Whitworth Street Planning Comparison

Since planning approval in 2016 the site has been purchased by Vision Manchester Limited. The client has engaged a full design team and RussellWBHO to update the detail design to the required regulations, agree a building contract and construct the development. Through this process a number of design changes are being proposed.

This updated document is being presented to Manchester City Council Planning Department to illustrate and explain the nature and extent of the proposed changes and to seek the Council's formal approval through the necessary planning process.

3.4 Proposed 1st Floor Plan

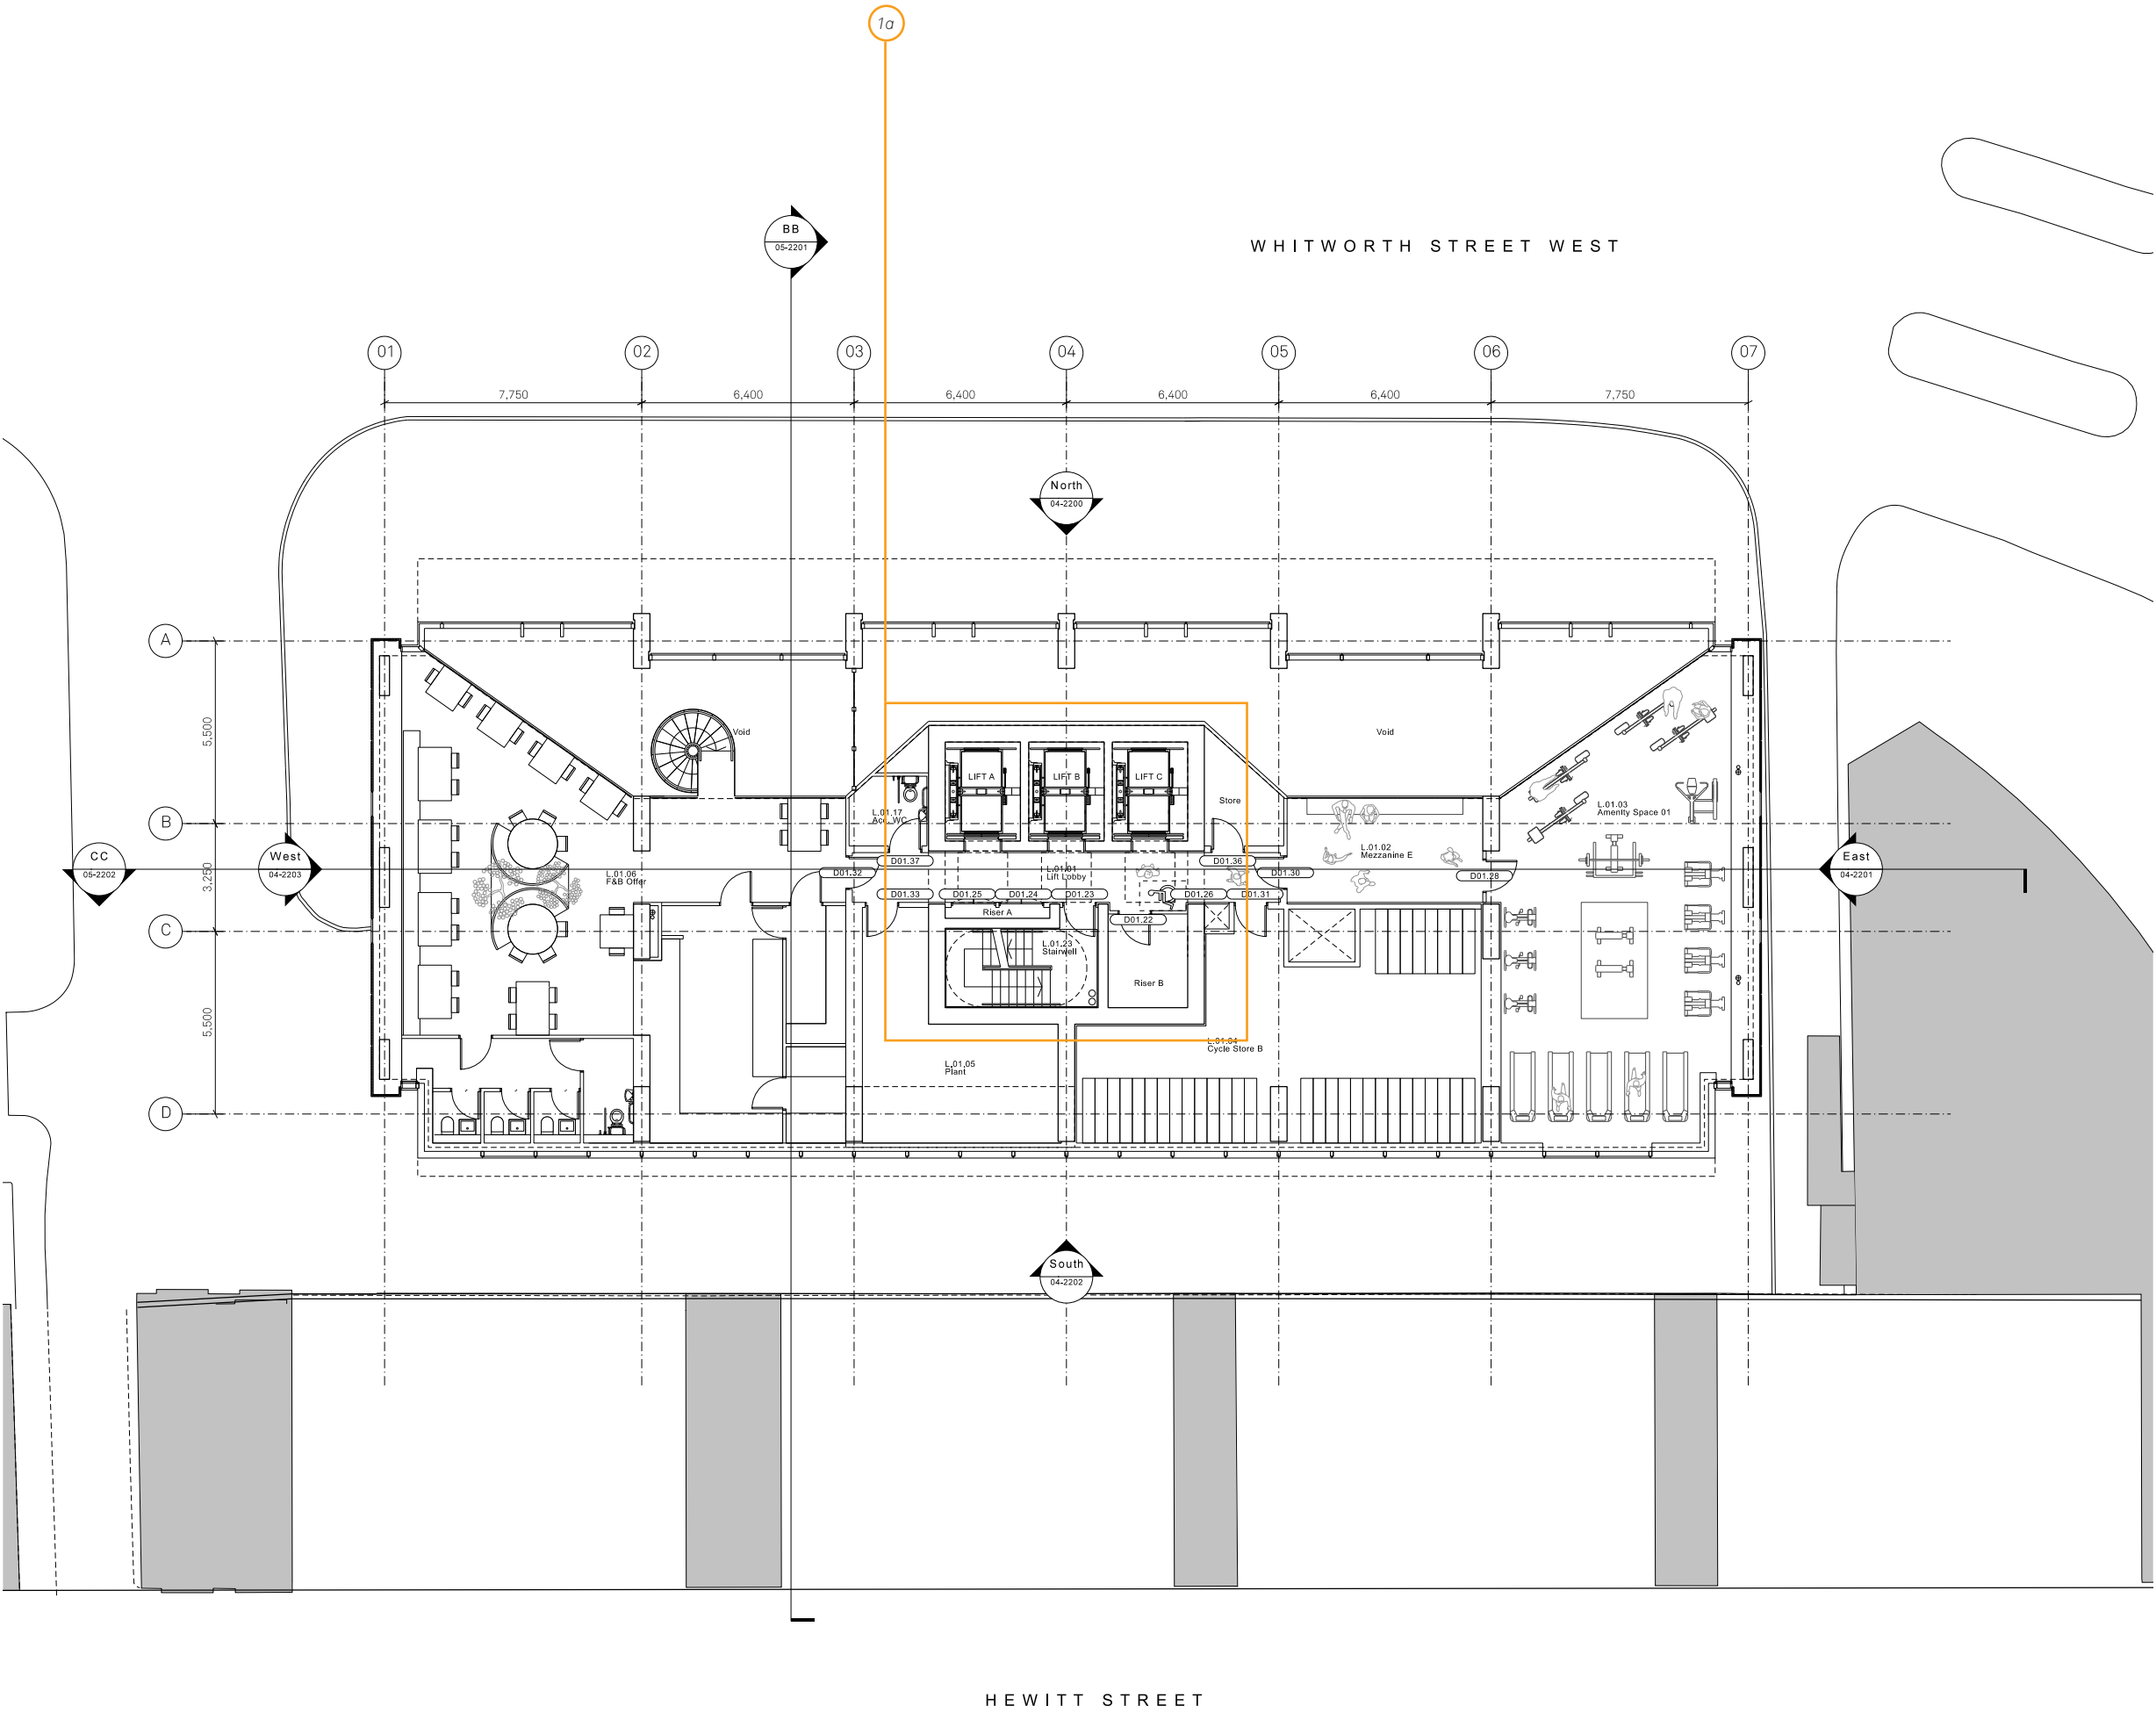
- 1a - Core Repositioned
- 1b - Main body of south facade to match north facade
- 1c - Entrance relocation
- 1d - Form of roof pavilion
- 1e - Apartment & amenity layouts
- 1f - Inclusion of commercial unit & dedicated entrance
- 2a - Reduced floor to floor heights
- 2b - Additional floor
- 2c - 2 no. Guest Beds & 2 no. 1 Bed become 2 no. 2 Bed & 2 no. 3 Bed
- 3 - South 'picture frame' reveal depth reduced by 600mm

3.6 Proposed 3rd Floor Plan

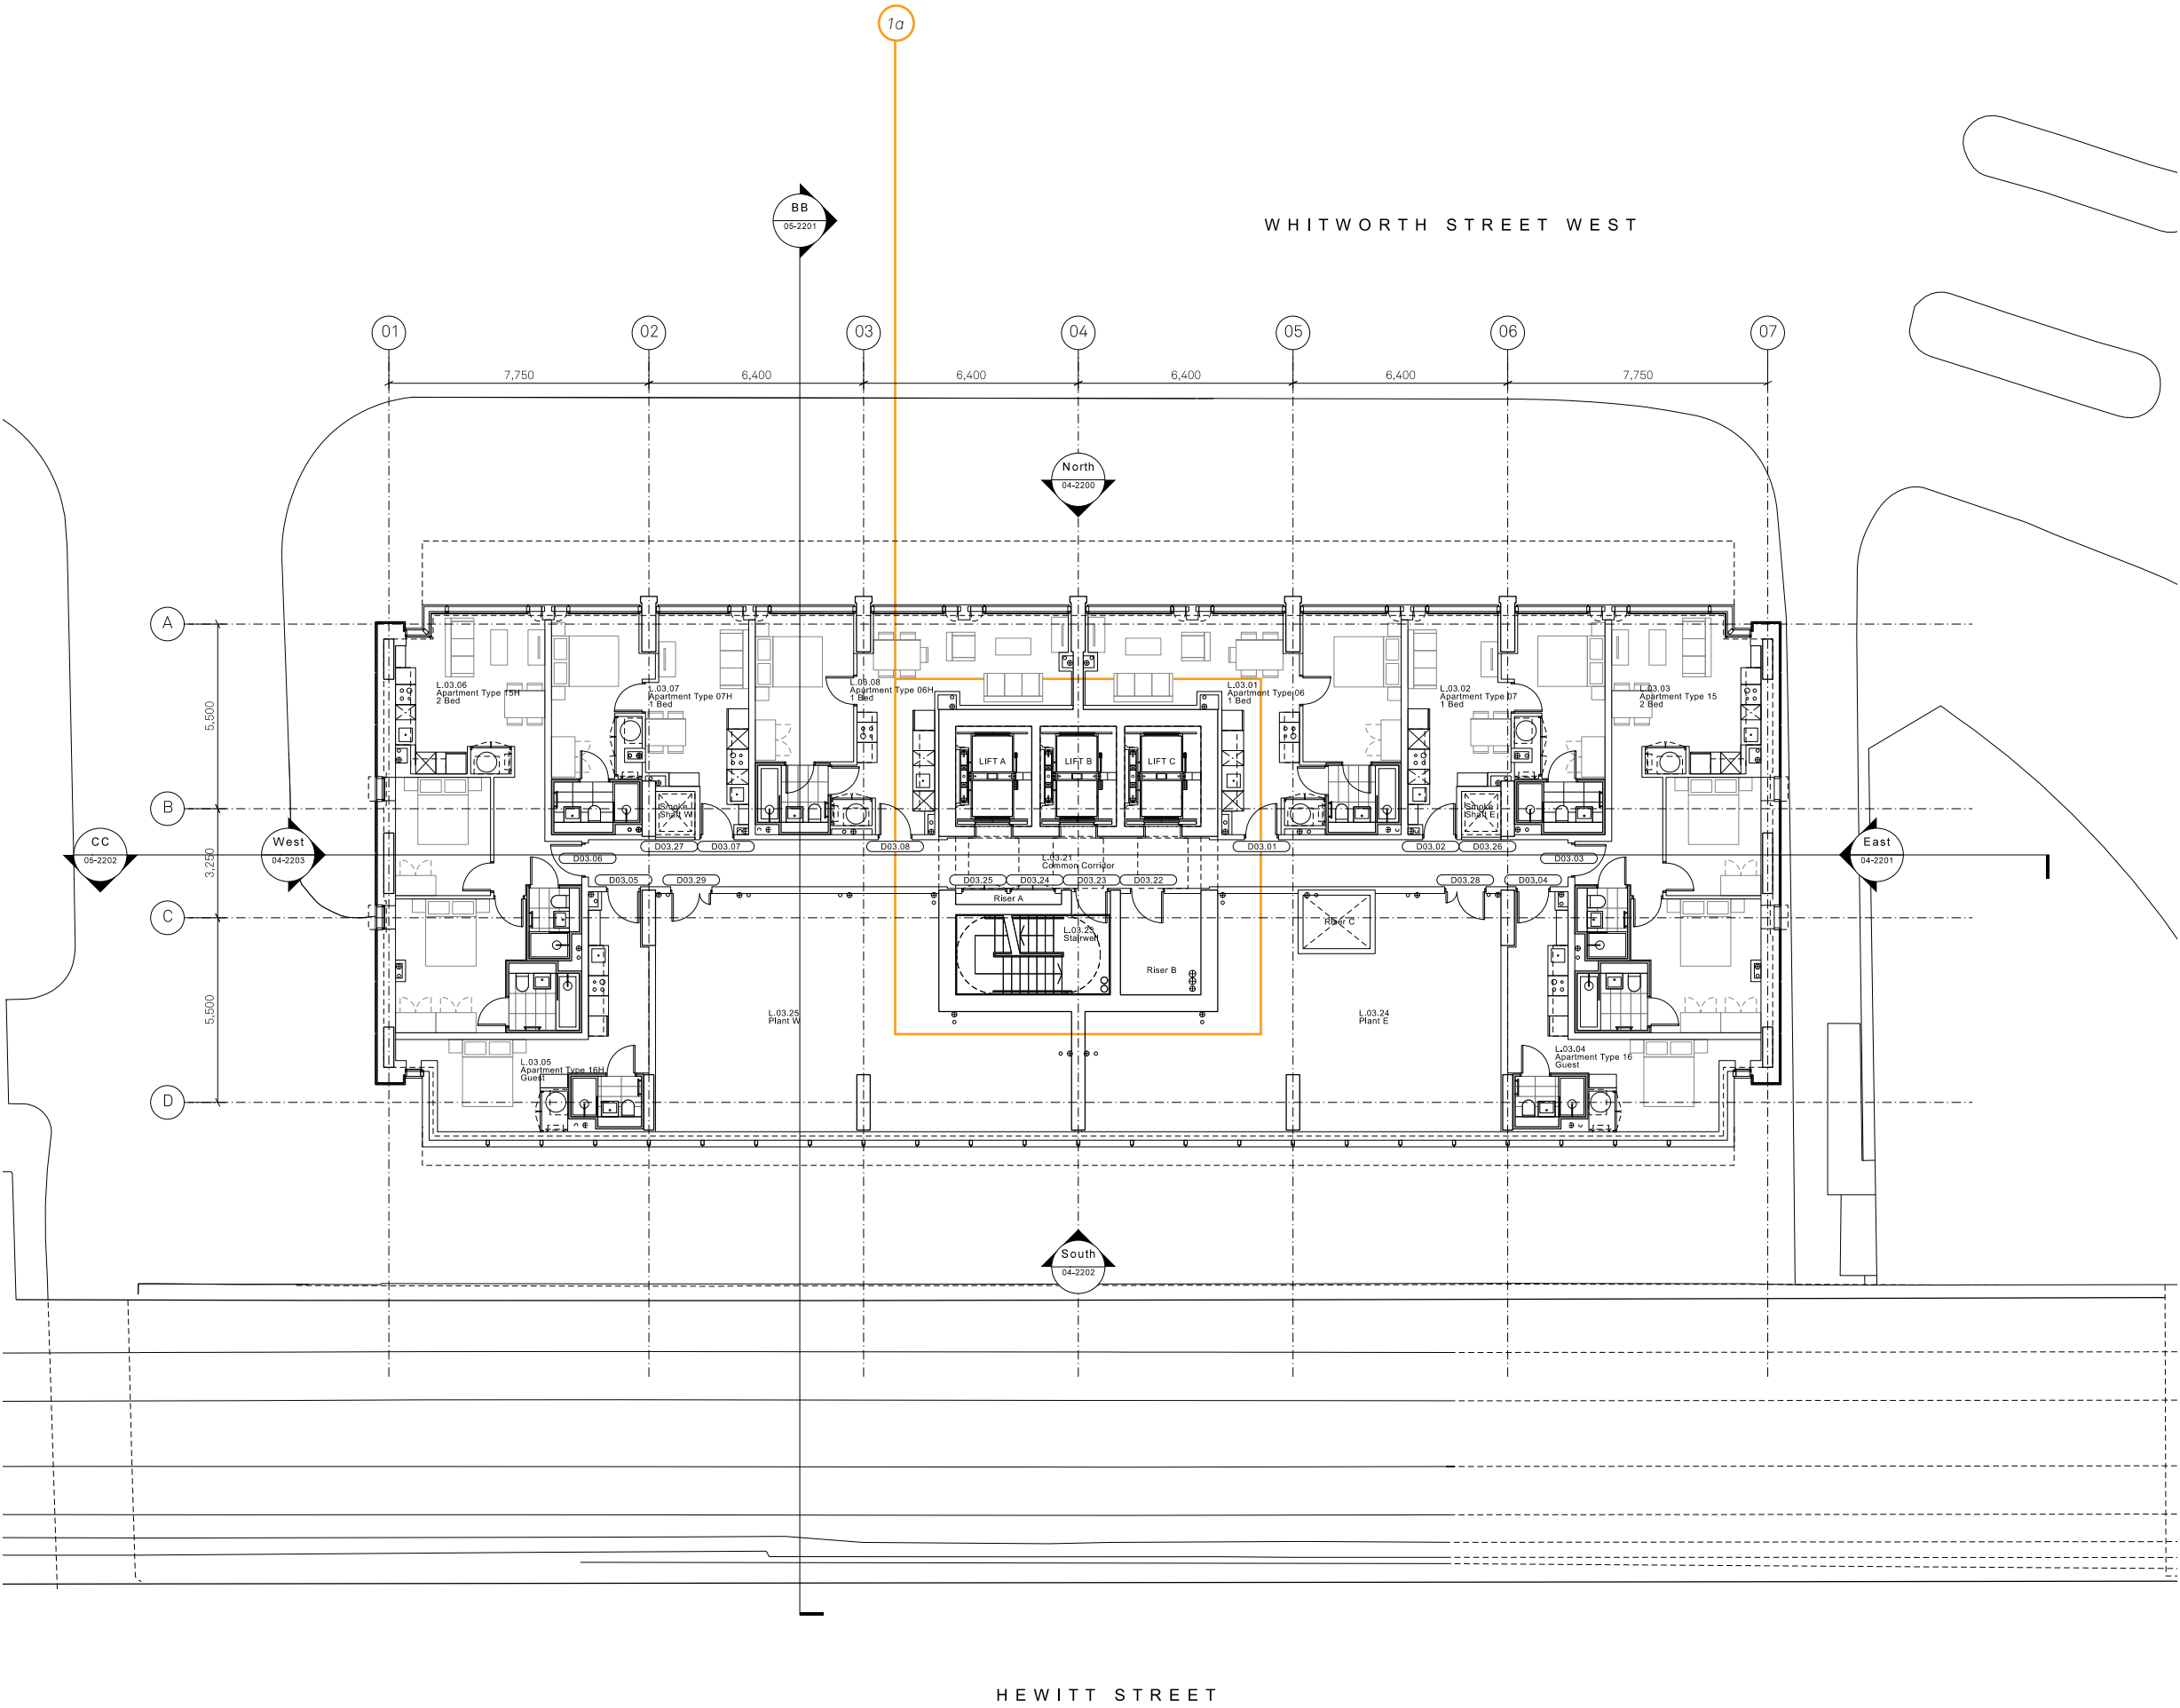
- 1a - Core Repositioned
- 1b - Main body of south facade to match north facade
- 1c - Entrance relocation
- 1d - Form of roof pavilion
- 1e - Apartment & amenity layouts
- 1f - Inclusion of commercial unit & dedicated entrance
- 2a - Reduced floor to floor heights
- 2b - Additional floor
- 2c - 2 no. Guest Beds & 2 no. 1 Bed become 2 no. 2 Bed & 2 no. 3 Bed
- 3 - South 'picture frame' reveal depth reduced by 600mm
